SUBJECT: ISSUANCE OF AMENDMENT NO. 115 TO FACILITY OPERATING LICENSE NPF-9 AND
AMENDMENT NO. 97 TO FACILITY OPERATING LICENSE NPF-17 - MCGUIRE
NUCLEAR STATION, UNITS 1 AND 2 (TACS 77546/77547)

The amendments replace the existing McGuire Units 1 and 2 reactor coolant system heatup and cooldown limit curves with revised curves (TS Figures 3.4-2, 3.4-3, 3.4-4 and 3.4-5), as well as revise the reactor vessel surveillance capsule withdrawal schedule (TS Table 4.4-5).

SAFETY EVALUATION BY THE OFFICE OF NUCLEAR REACTOR REGULATION
RELATED TO AMENDMENT NO. 115 TO FACILITY OPERATING LICENSE NPF-9
AND AMENDMENT NO. 97 TO FACILITY OPERATING LICENSE NPF-17
DUKE POWER COMPANY
DOCKET NOS. 50-369 AND 50-370
MCGUIRE NUCLEAR STATION, UNITS 1 AND 2

FIGURE 3.4-2

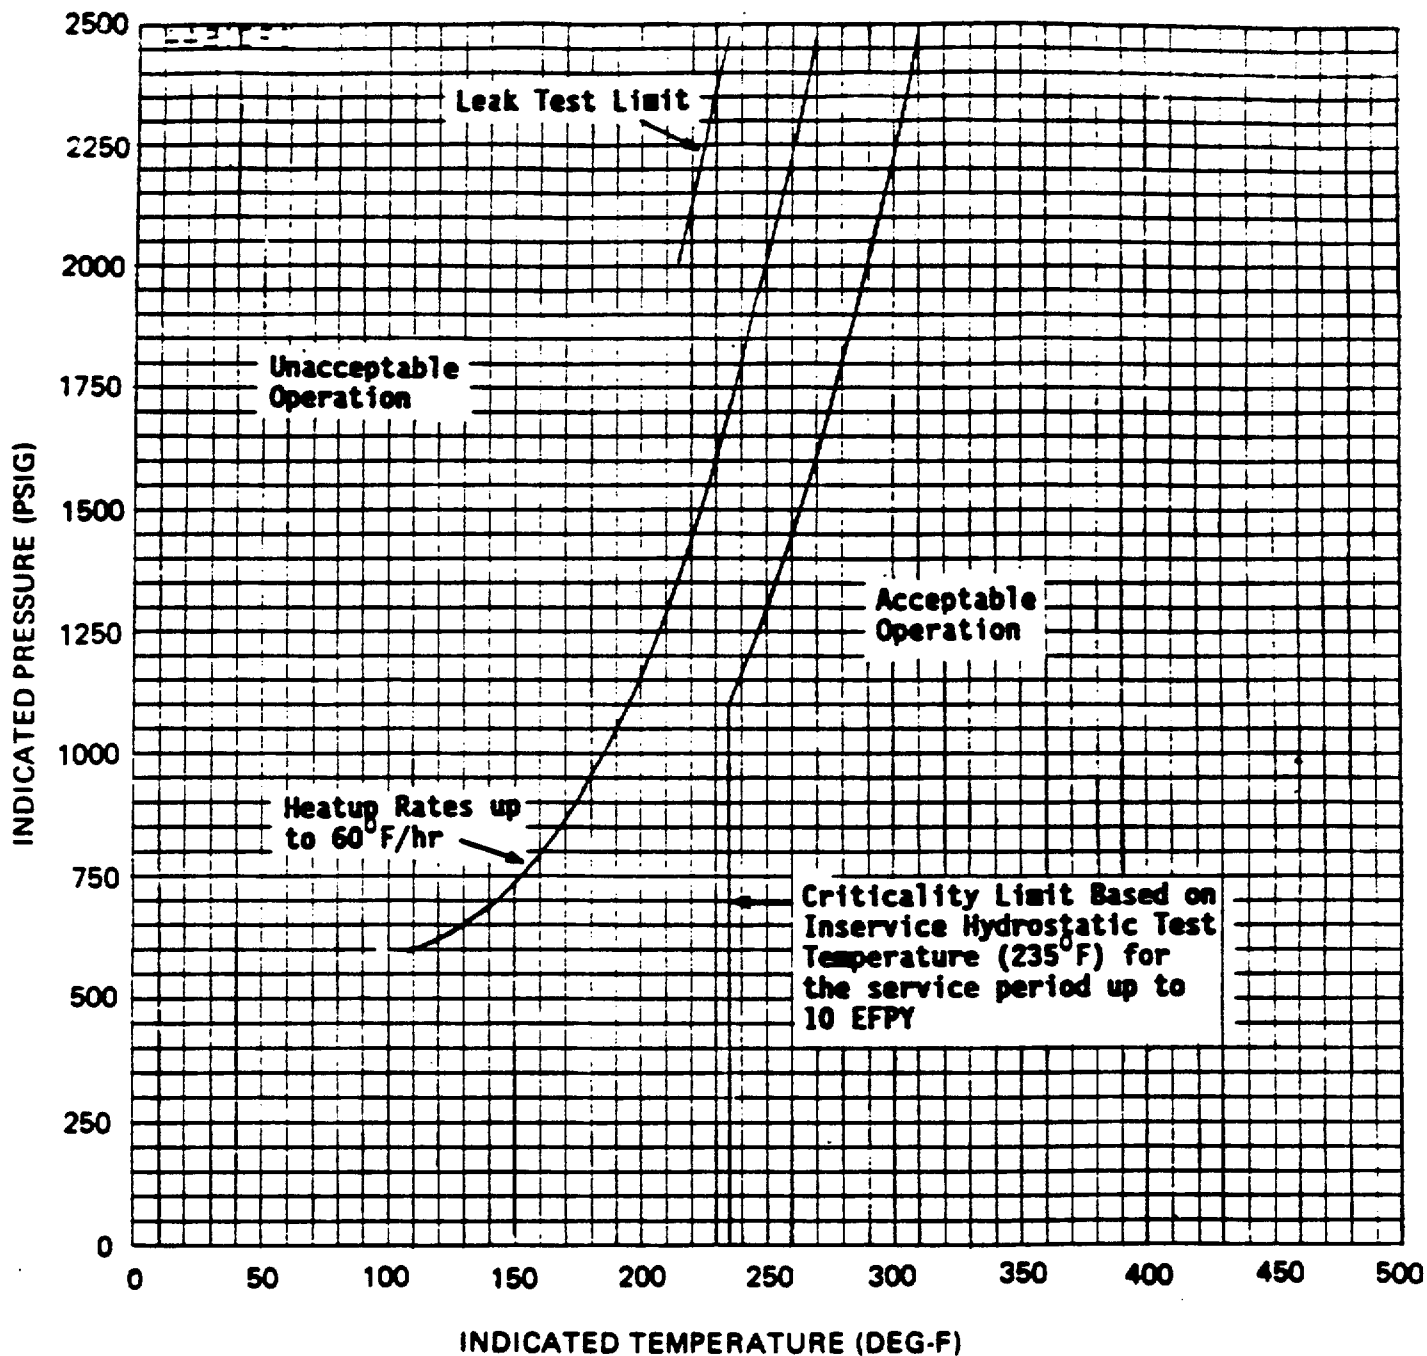
CURVE APPLICABLE FOR HEATUP RATES UP TO 60°F/HR FOR THE SERVICE PERIOD UP TO 10 EFPY. CONTAINS MARGINS OF 10°F AND 60 PSIG FOR POSSIBLE INSTRUMENT ERRORS.

MATERIAL BASIS
 CONTROLLING MATERIAL—LONGITUDINAL
 COPPER CONTENT: 0.21 wt% WELD
 RT NDT INITIAL: -50°F
 RT NDT AFTER 10 EFPY: 1/4T, 185.5°F
 3/4T, 113°F

For the limiting beltline material, longitudinal weld seam M1.22, the staff calculated the ART to be $164^{\circ}F$ at $1/4T$ (T = reactor vessel beltline thickness) and $110^{\circ}F$ at $3/4T$. The staff used a neutron fluence of $4.17E18$ n/cm^2 at $1/4T$ and $1.48E18$ n/cm^2 at $3/4T$. The ART was determined by Section 1 of RG 1.99, Rev. 2, because the limiting material was not in the surveillance capsules.

The licensee calculated the ARTs of $165.5^{\circ}F$ at $1/4T$ and $113^{\circ}F$ at $3/4T$ for the same limiting material, longitudinal weld seam M1.22. The licensee's ARTs are more conservative than the staff's ARTs and, therefore, are acceptable. Substituting the ART of $165.5^{\circ}F$ into the equations in SRP 5.3.2, the staff verified that the proposed P/T limits for heatup, cooldown, and hydrotest meet the beltline material requirements in Appendix G of 10 CFR Part 50.

FIGURE 3.4-3

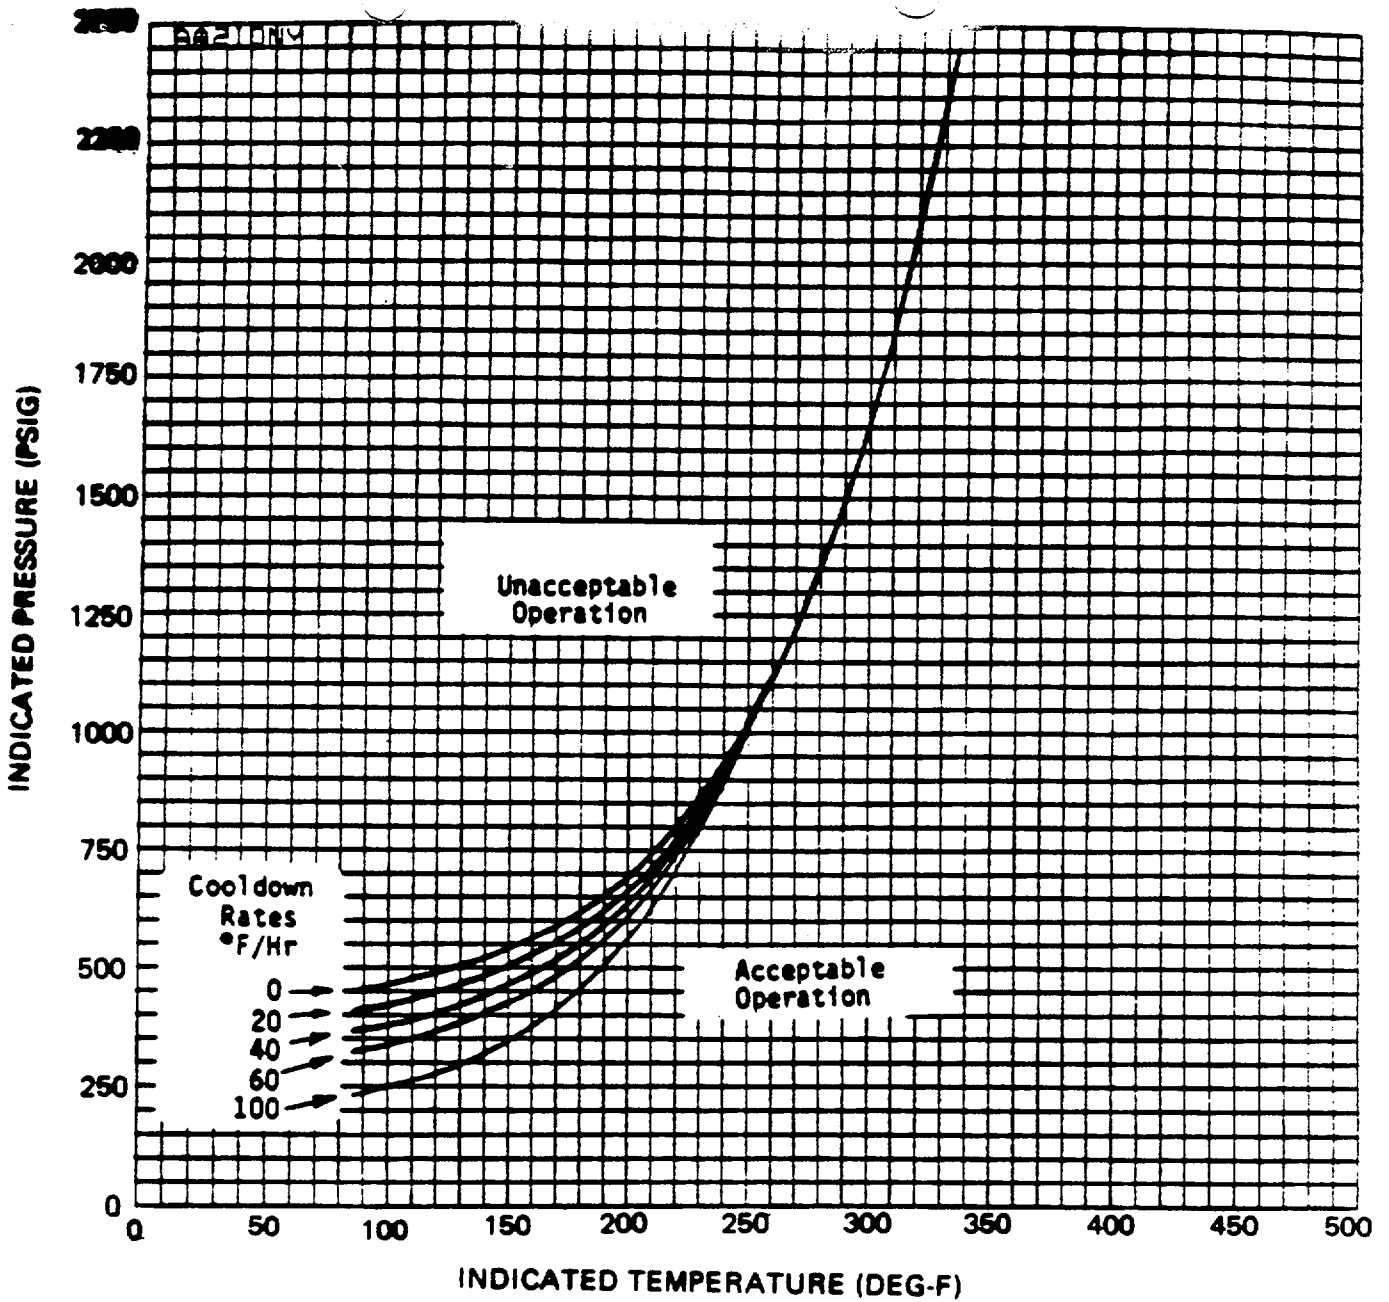
CURVES APPLICABLE FOR HEATUP RATES UP TO 60°F/HR FOR THE SERVICE PERIOD UP TO 10 EFY. CONTAINS MARGINS OF 10°F AND 60 PSIG FOR POSSIBLE INSTRUMENT ERROR.

MATERIAL BASIS
 CONTROLLING MATERIAL: LOWER SHELL
 COPPER CONTENT: 0.15w%
 RTNDT INITIAL: -30°F
 RTNDT AFTER 10 EFY: 1/4T, 90°F
 3/4T, 81°F

For the limiting beltline material, the lower shell forging, the staff calculated the ART to be 89.5°F at $1/4T$ (T = reactor vessel beltline thickness) and 60.6°F for $3/4T$ at 10 EFPY. The staff used a neutron fluence of $3.97\text{E}18$ n/cm^2 at $1/4T$ and $1.43\text{E}18$ n/cm^2 at $3/4T$. The ART was determined by Section 1 of RG 1.99, Rev. 2, because the limiting material was not in the surveillance capsule.

The licensee calculated an ART of 90°F at $1/4T$ for the same limiting forging. The staff judges that the licensee's ART of 90°F is more conservative than the staff's ART of 89.6°F , and it is acceptable. Substituting the ART of 90°F into equations in SRP 5.3.2, the staff verified that the proposed P/T limits for heatup, cooldown, and hydrotest meet the beltline material requirements in Appendix G of 10 CFR Part 50.

FIGURE 3.4-4 MCGUIRE UNIT 1, REACTOR COOLANT SYSTEM, COOLDOWN LIMITATIONS NRC RG 1.90 REV 2 APPLICABLE FOR THE FIRST 10 EFPY

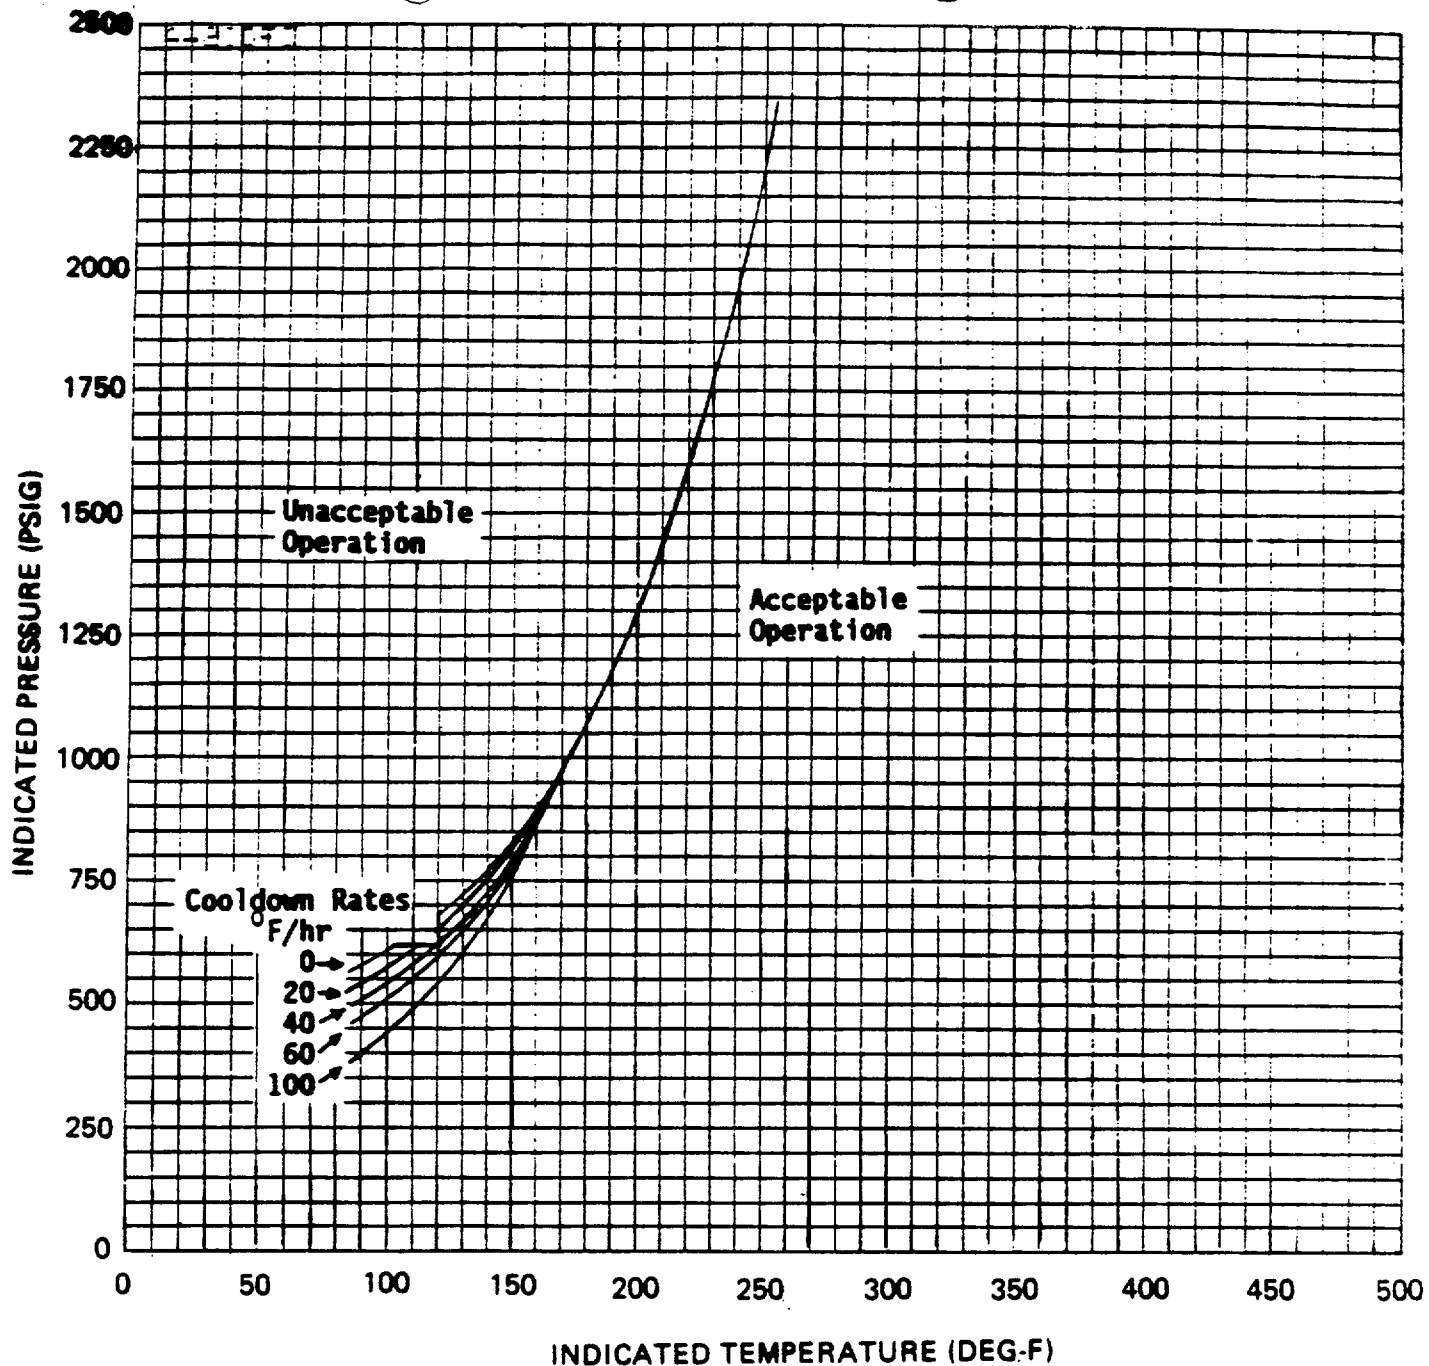
CURVE APPLICABLE FOR COOLDOWN RATES UP TO 100 °F/HR FOR THE SERVICE PERIOD UP TO 10 EFPY. CONTAINS MARGINS OF 10 °F AND 60 PSIG FOR POSSIBLE INSTRUMENT ERROR.

MATERIAL BASIS
 CONTROLLING MATERIAL - LONGITUDINAL
 COPPER CONTENT: 0.21 wt% WELD
 RT NDT INITIAL: -50 °F
 RT NDT AFTER 10 EFPY: 1/4T, 166.5 °F
 3/4T, 113 °F
